RECOMMENDED SERVICE BULLETIN

RSB 42-025/1

Fuel System – Fuel Probe
ATA Code: 28

WI-RSB-42-025

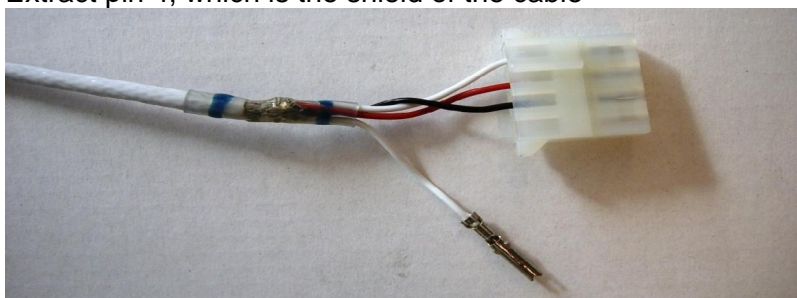
If a 4-pole connector is installed that connects the fuel probe, replace this connector with a 3-pole connector, as shown below.

Extract pin 4, which is the shield of the cable

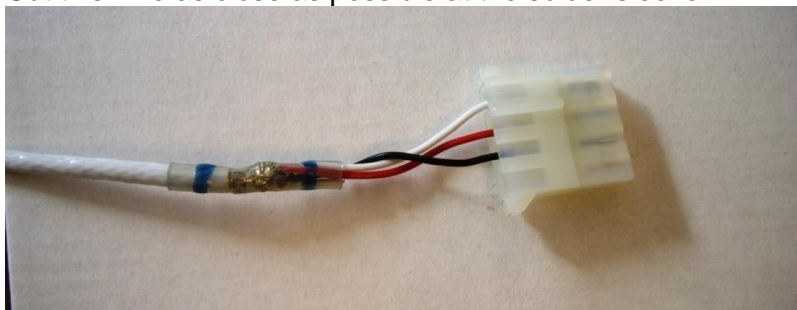
Cut this wire as close as possible at the solder sleeve

Extract the other three wires

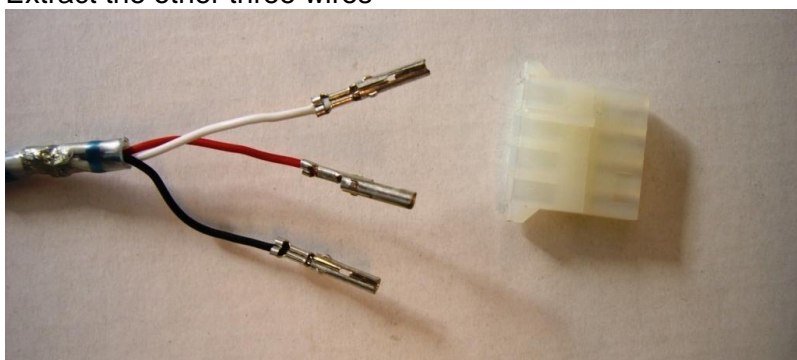
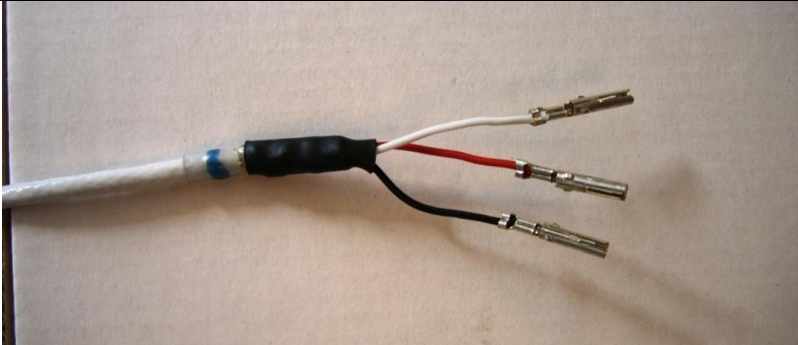
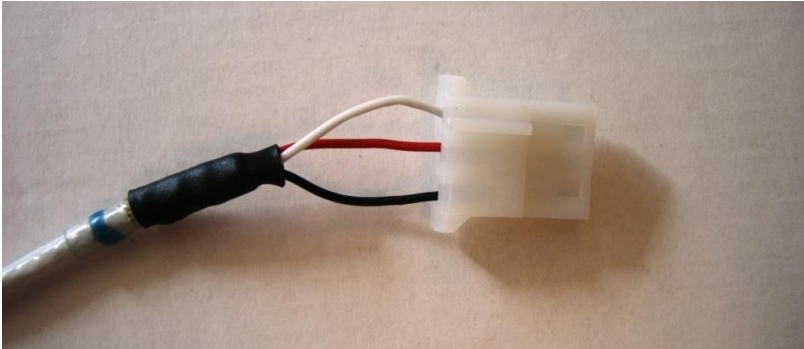
Put a 6.4mm heat shrink over the cut wire and shrink it by using a heat gun.

<p>Insert the wires into the new 3-pole connector (P/N 1-0480303-0), refer also to D60-9231-60-01, sheet 4.</p> 
4	Install improved Fuel Probe. Refer to Section 28-40-00 – Paragraph 2.B and drawing D60-2817-00-00.
5	Perform Items 1 to 4 for RH side.
6	Clean working area and check for foreign objects.
7	Perform functional check of altered, repaired and new parts.
8	Test all systems in working area for function.
9	Make necessary entries in aircraft logs.
